WEST SUSSEX COUNTY COUNCIL CONSULTATION

TO:	Arun District Council FAO: Simon Davis
FROM:	WSCC – Highway Authority
DATE:	16 March 2026
LOCATION:	Land Adjacent to Woodgate Nurseries Lidsey Road Aldingbourne PO20 3SU
SUBJECT:	AL/16/26/NMA Non-material amendment following the grant of AL/143/24/RES relating to paths north of Plots 26 & 27 and east of Plots 27-16, to reduce the width to 2m for pedestrian use, associated with the delivery of a 2m footway along Lidsey Road (path around Plot 15 provided as 3m). Amendment to path north of pumping station and east of sub-station, to increase width to 3m for shared pedestrian/cycle use (on opposite side of spine road to Plots 43-48), with directional signage for cyclists and amendment to materials layout, to enable contrasting brick detailing (use of orange feature brick on red brick plots and red feature brick on orange brick plots).
DATE OF SITE VISIT:	n/a (desktop study undertaken for purposes of this NMA application)

RECOMMENDATION:	Advice

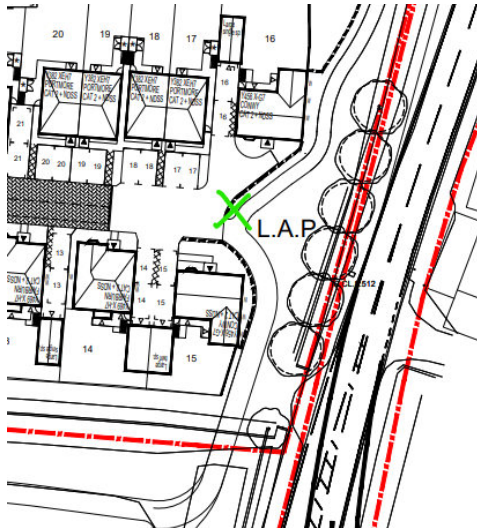
Having reviewed Drawing No. ST-22-01 revision 'W', the Road Safety Audit (2nd stage ½ Safety Audit – 22 December 2025, reference – S/BDWWoodgate-S278.1-2.6 Rev 'A' produced by Mayer Brown Ltd) and associated Road Safety Audit Decision Log as submitted, the Highway Authority raises no objection to the changes proposed. However, it does recommend that one further cycle route directional sign be provided in the location shown below (marked with a green cross).
